TO: All Design Section Staff
FROM: Bijan Khaleghi
DATE: October 3, 2016
SUBJECT: Hinge Diaphragms at Interior Piers

Bridge Design Manual Revisions:

End Type C (Intermediate Hinge Diaphragm)
Figure 5.6.2-5

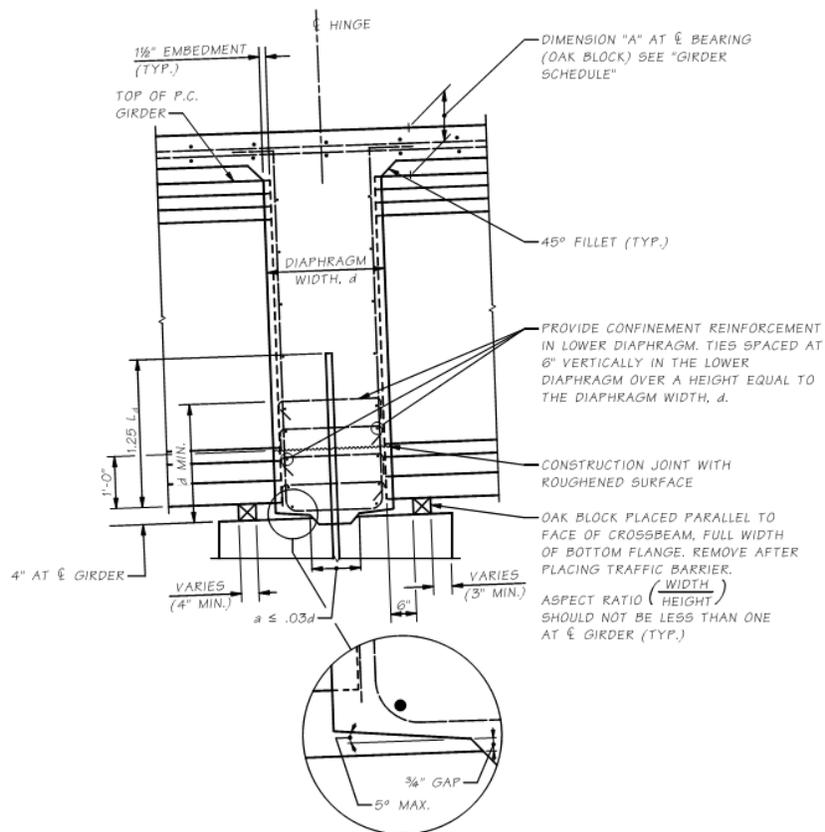
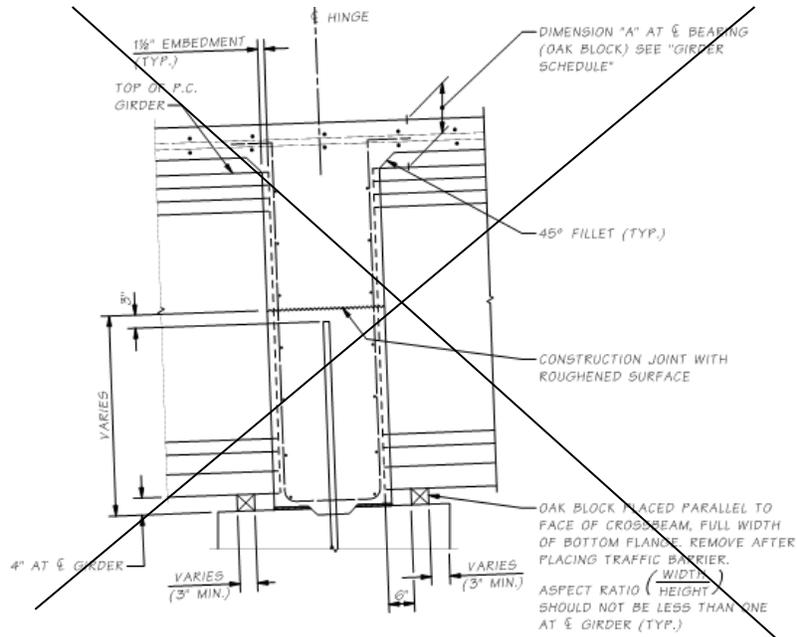
Section 5.6.2 E.3 End Type C shall be revised as follows:

End Type C as shown in Figure 5.6.2-5 is for continuous spans and an intermediate hinge diaphragm at an intermediate pier. There is no bearing recess and the girder is temporarily supported on oak blocks. ~~In the past, this detail was used in low seismic areas such as east of the Cascade Mountains. This end type shall not be used on new structures and is restricted to the widening of existing bridges with hinge diaphragms at intermediate piers.~~ This detail may be used to reduce the seismic demand at an intermediate pier by allowing rotation about the axis parallel to the crossbeam. The reduced pier stiffness will lower the plastic overstrength shear demand (V_{po}), allow for shorter columns and eliminate the plastic hinge at the top of each column. While the diaphragm hinge is intended to act as a pin, there may be some residual stiffness at the connection that shall be determined by the designer.

This stiffness will move the point of inflection down the pier, inducing some plastic overstrength shear demand.

The hinge connection should be assumed pinned to determine the pier displacement and ductility demand for seismic analysis.

The designer shall check the edge distance and provide a dimension that prevents edge failure, or spalling, at the top corner of the supporting cross beam for load from the oak block including dead loads from girder, deck slab, and construction loads.

For prestressed concrete girders with intermediate hinge diaphragms, designers shall:

- a. Check size and minimum embedment in crossbeam and diaphragm for hinge bars. Bars shall be sized based on interface shear due to calculated plastic overstrength shear force (V_{po}) from the column while ignoring the concrete cohesion and axial load contributions.

- b. Design the width of the shear key to take the factored vertical bearing force per AASHTO LRFD 5.7.5 at the Strength limit state. The maximum shear key width shall be limited to $0.3d$, where d is the width of the diaphragm.

- c. Confinement reinforcement shall be added to the diaphragm between the girders over a vertical distance equal to or greater than the diaphragm width. Confinement shall be no less than #4 ties bars spaced at 12 in. longitudinally and staggered 6 in. vertically.

- d. The throat of the hinge gap shall be no larger than 0.75 in. The bottom of diaphragm may taper up to 5 degrees maximum to allow for 1.5 times the elastic service, strength or extreme rotation. The material used to form the gap shall be strong enough to support the wet concrete condition and shall be removed after concrete placement.

- e. Check interface shear friction at girder end (see Section 5.2.2.C.2).
